Technical Memorandum
Siting Study for Relocation of the Goleta
Outfall Vault

PREPARED FOR
Goleta Sanitary District

TECHNICAL MEMORANDUM

SUBJECT: Goleta Sanitary District Vault Protection Plan Review and Potential Relocation

Figure 1. Outfall Vault Relocation Option Alternative 1

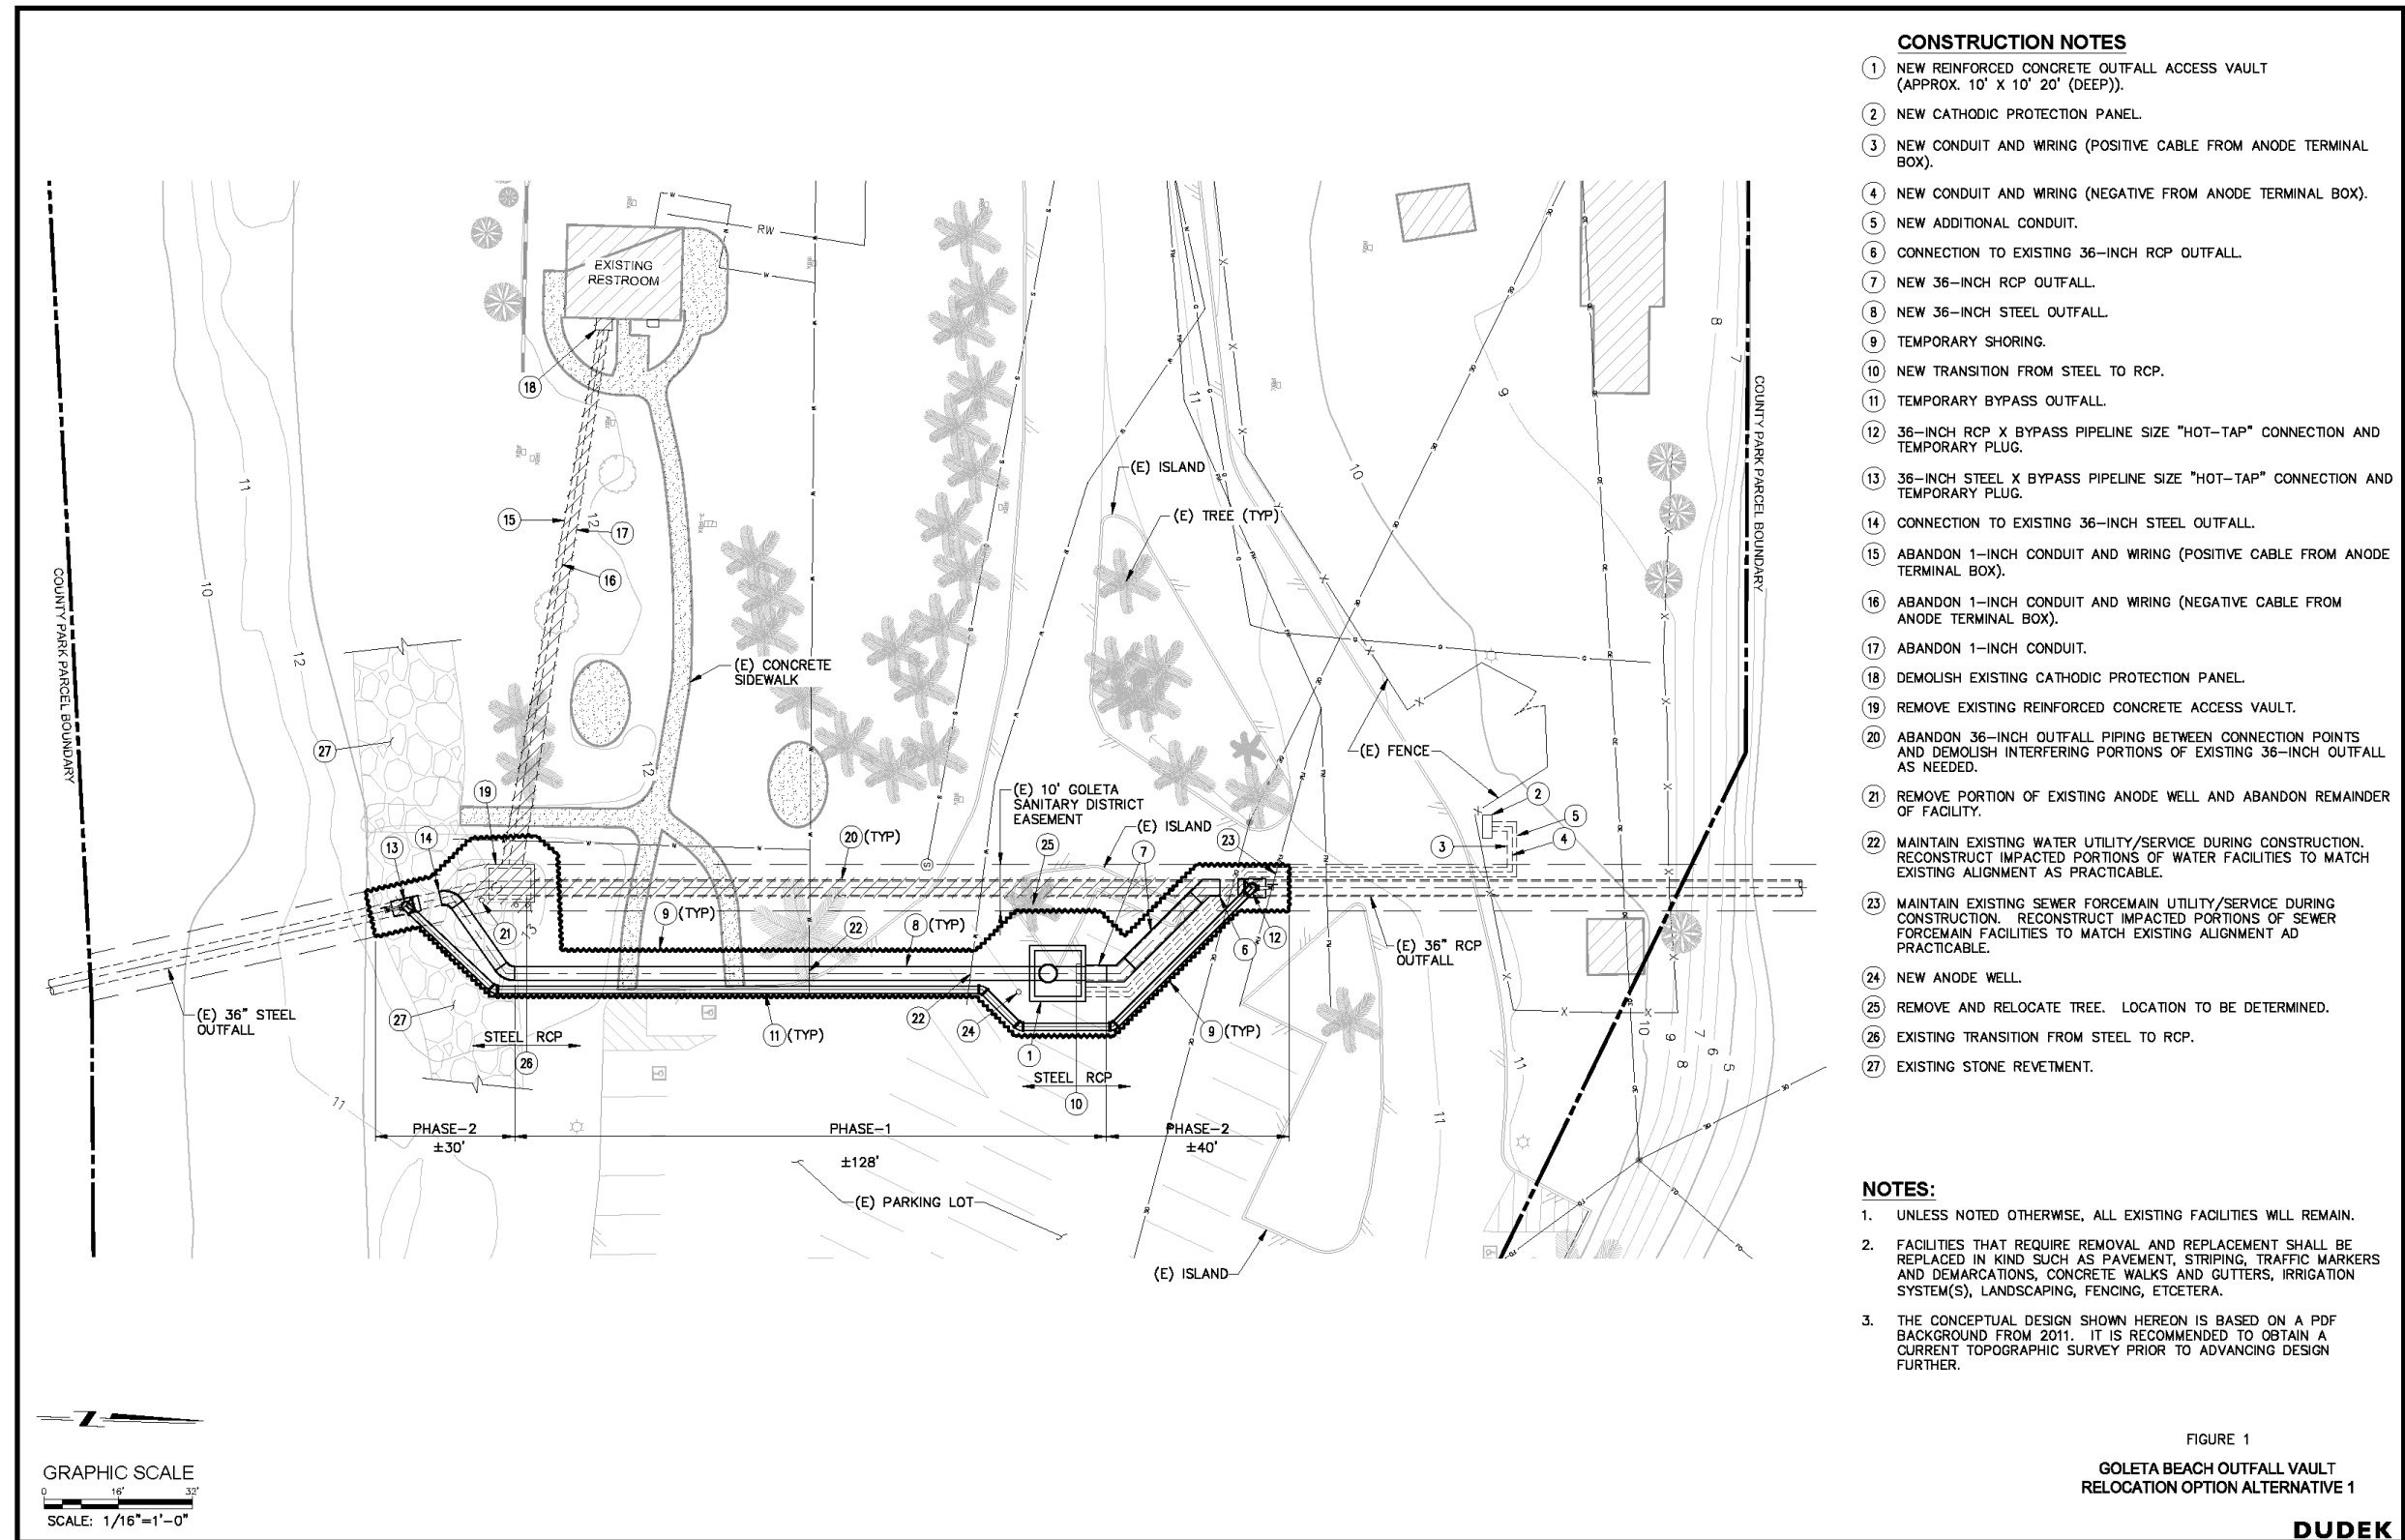
Alternative 1

This alternative would move the vault approximately 128 feet landward of the existing vault. With the revetment in place this will significantly reduce or eliminate the impact of any wave overtopping on the vault (inundation). If the revetment is removed and the retreat rate is ~3 feet/yr, the shoreline will be at the vault in about 38 years.

Figure 2. Outfall Vault Relocation Option Alternative 2

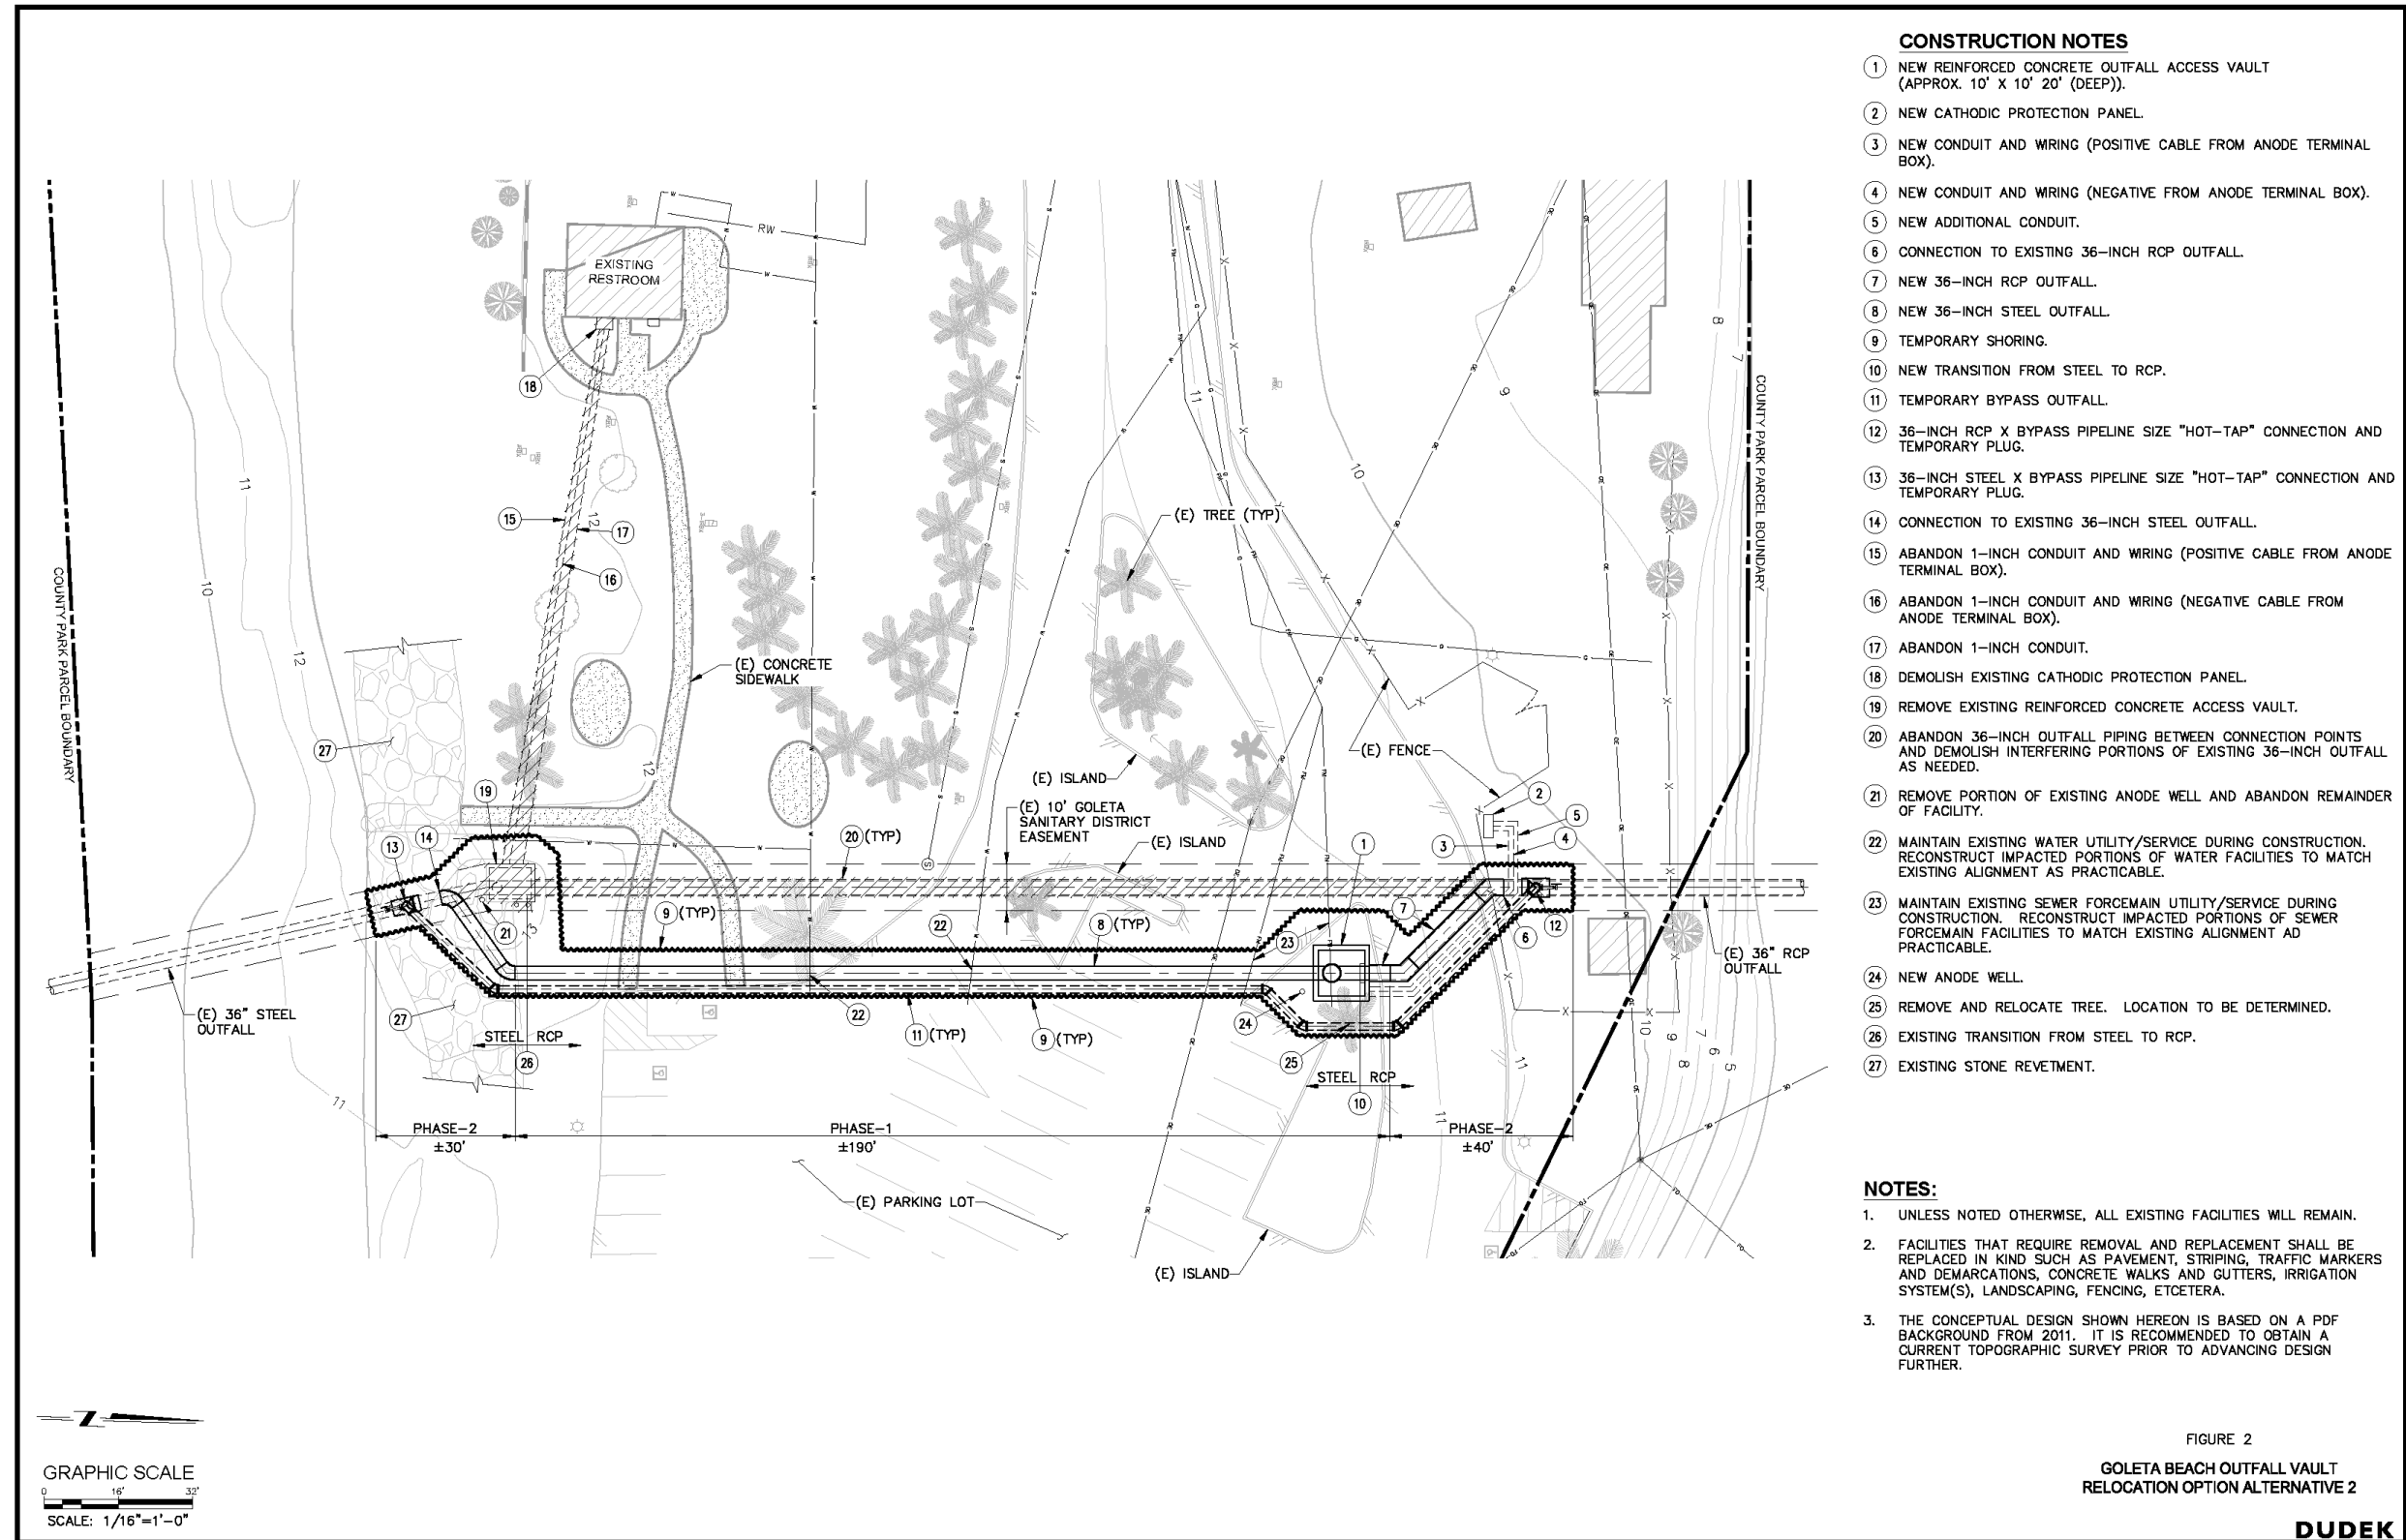
Alternative 2.

This alternative would move the vault approximately 190 feet landward of the existing vault. With the revetment in place this will eliminate the impact of any wave overtopping on the vault. If the revetment is removed and the retreat rate is ~3 feet/yr, the shoreline will be at the vault in about 57 years.
